APPENDIX B MITIGATION MONITORING, COMPLIANCE, AND REPORTING PROGRAM REQUESTS AND AUTHORIZATIONS

PUBLIC UTILITIES COMMISSION

Subject: Salt Creek Substation—Review of Minor Project Refinement Request #1

SDG&E's Proposed Minor Project Refinement #1

Erosion Repair Location Map Detail Map

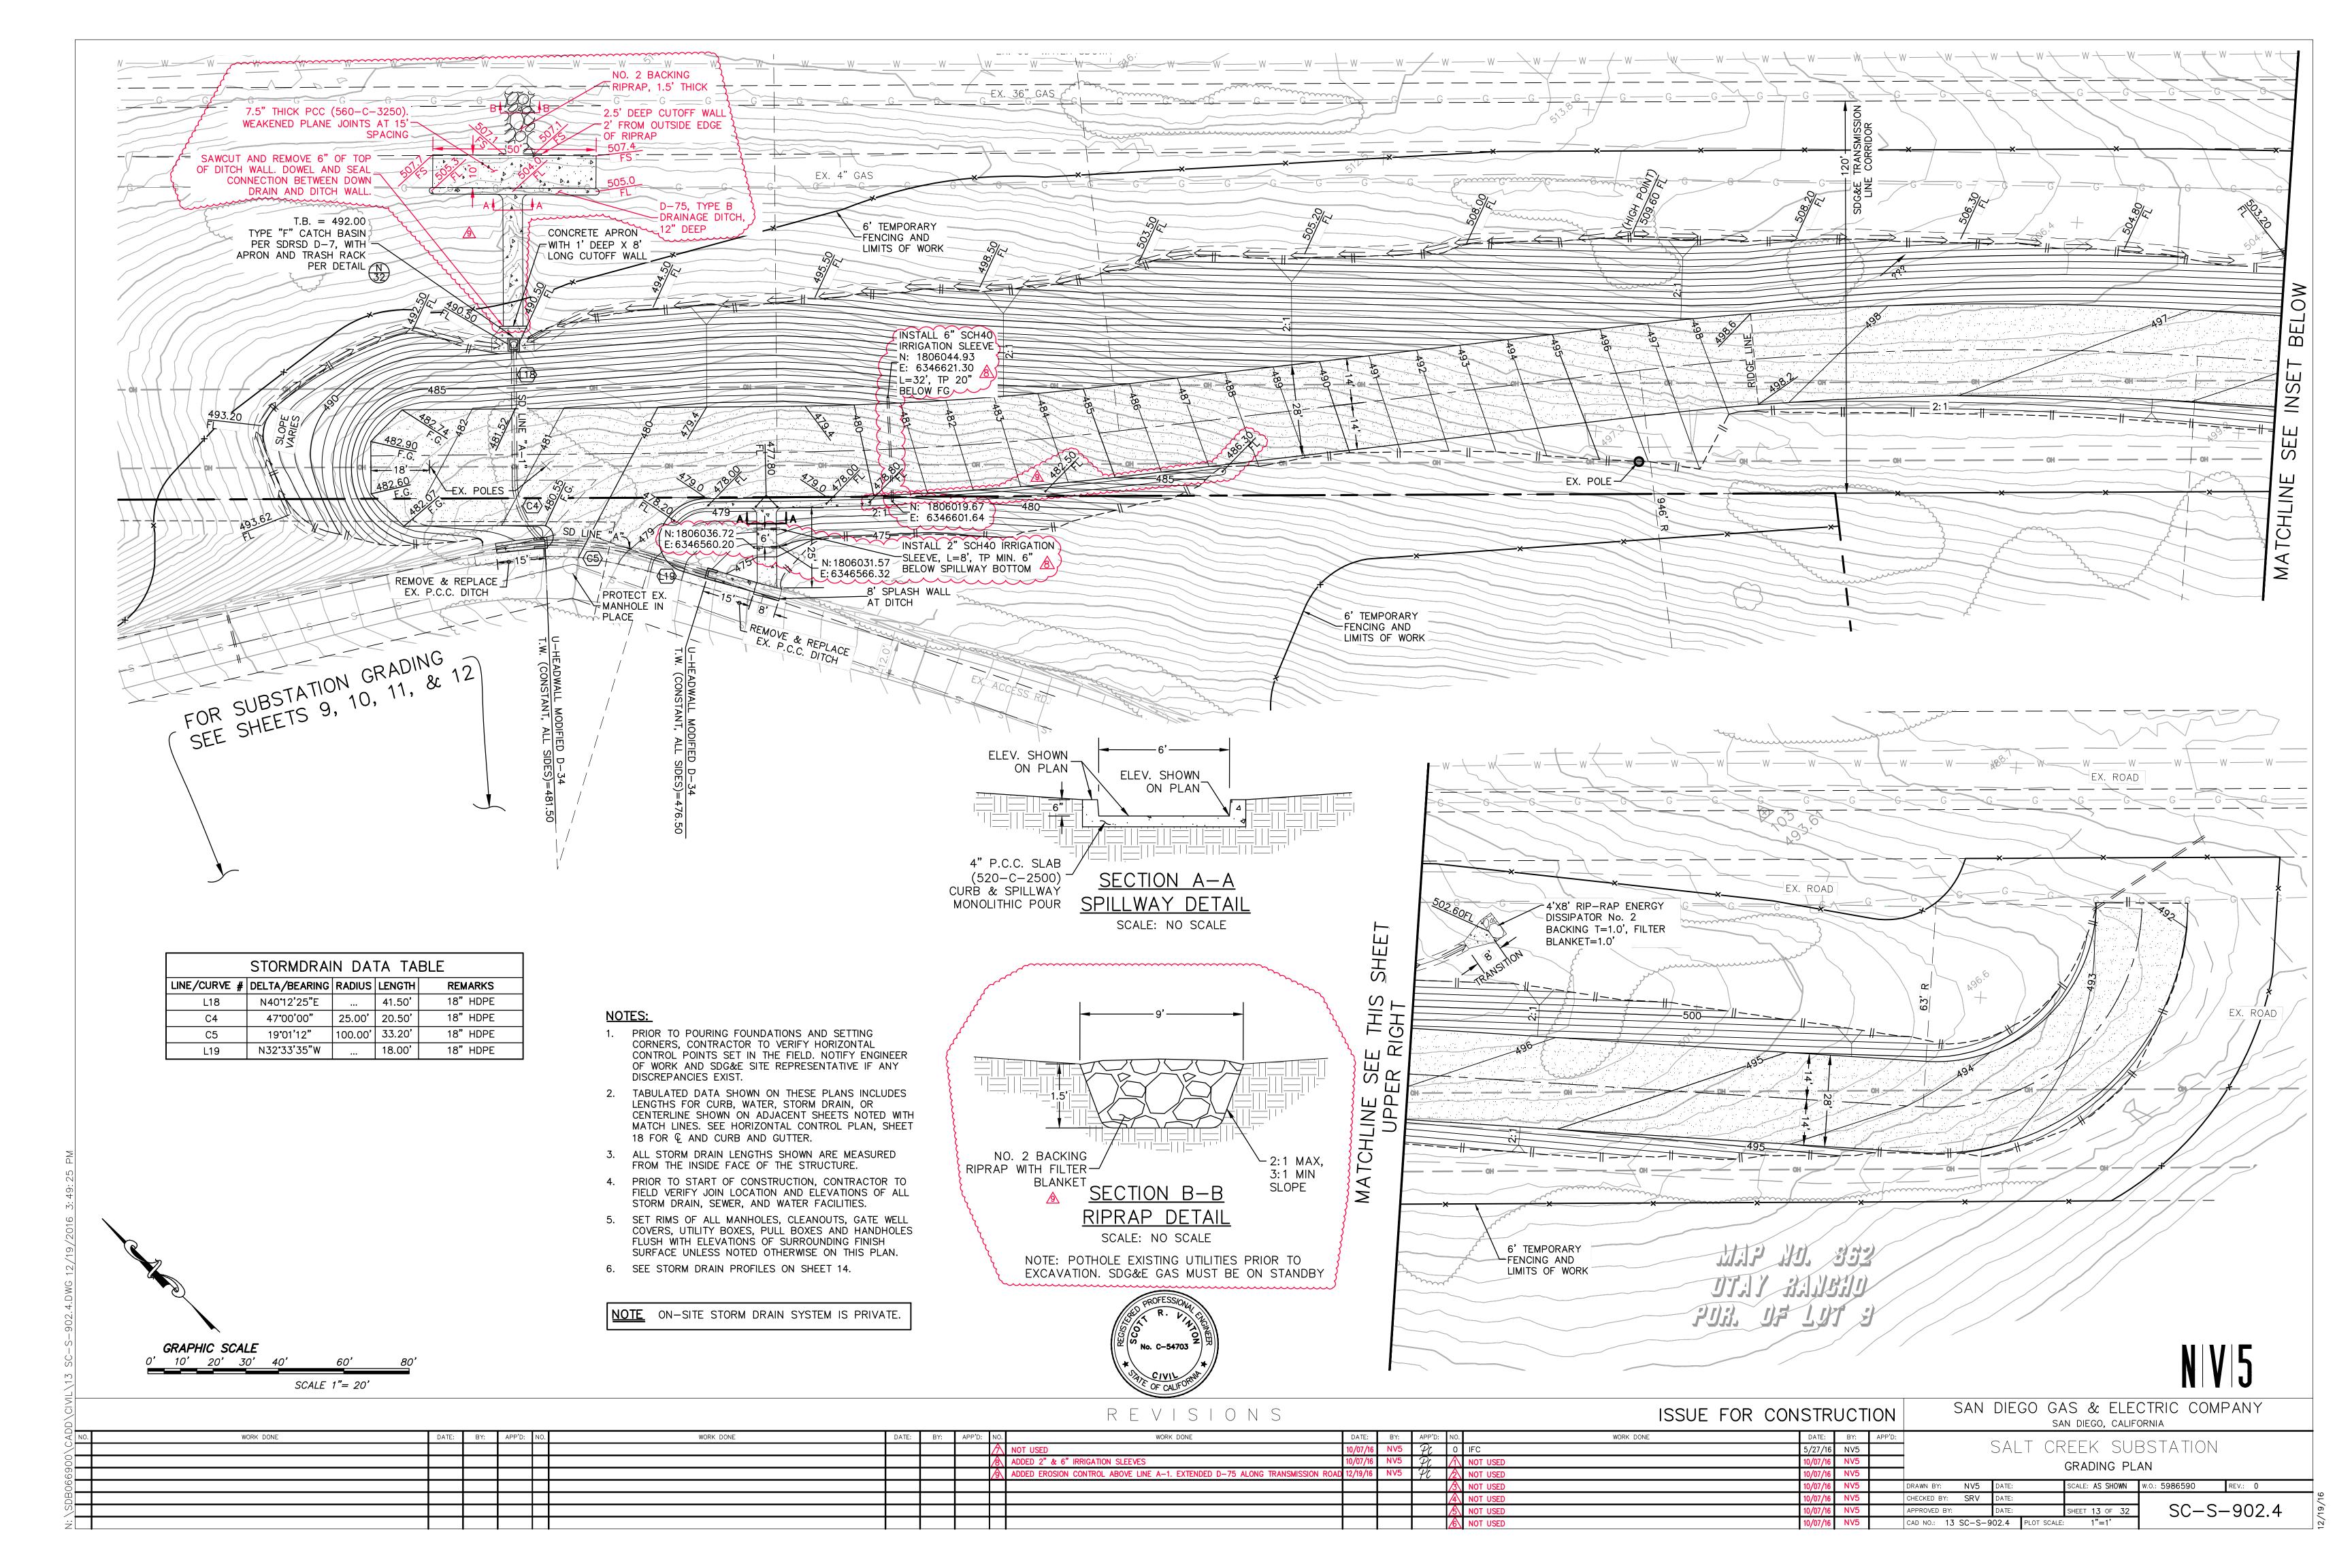
SDG&E is requesting authorization to create a concrete spillway above the SD-Line-A1 catch basin, a 50' long by 10 wide concrete road with an attached brow ditch, and place 5 tons of 6" rock in the large rill between the Upper and Lower Transmission Corridor Roads, as a BMP measure, between the project limit fence and the Upper Transmission Corridor Road. The spillway, road, brow ditch, and rock will be used to reduce the storm water velocity in the rill, and minimize the amount of soil erosion. This is the final BMP solution to replace the prior interim BMP (MPR #6)

Work to be performed would occur in an approximately 50' wide by 70' long x 3' deep area. The attached figure (Attachment 1) shows the location of the work to be performed. Equipment used to perform the work may include a backhoe (1), loader (1), crew truck (1), dump truck (1), concrete trailer (1), pump and concrete trucks (one at a time).

MRP #7 would authorize the creation of a concrete spillway above the SD-Line-A1 catch basin, a 50-foot-long by 10-foot-wide concrete road with an attached brow ditch, and placement of 5 tons of 6-inch rock in the large rill between the upper and lower transmission corridor roads. The spillway, road, brow ditch, and rock will be used to reduce the stormwater velocity in the rill, and minimize the amount of soil erosion. This is the final BMP solution to replace the prior interim BMP (MPR #6).
